Migration Solutions

Bulletin 700-FE and 700-FS
Timing Relays

Publication MIGRAT-PP056B-EN-P - November 2023 | Supersedes Publication MIGRAT-PP056A-EN-P - May 2022

A note on functional replacements:

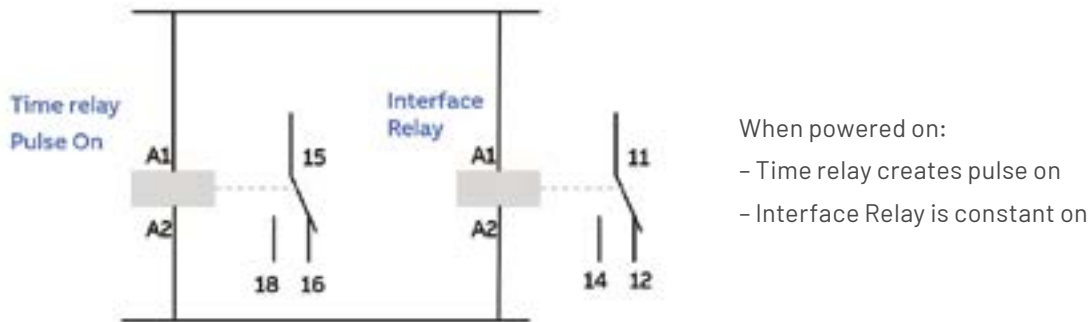
All replacements require that the T Range (for 700-FS) or range (for 700-FE) dials be set to the desired time range. The multi-function products (700-FSM* and 700-FEM*) must be set to the desired function code letter. For details on the new timing functions, please see publication 700-TD552H-EN-P.

Where a 700-FS replaces a 700-FE, or vice versa, the dimensions are different, and any associated mechanical drawings would require some correction.
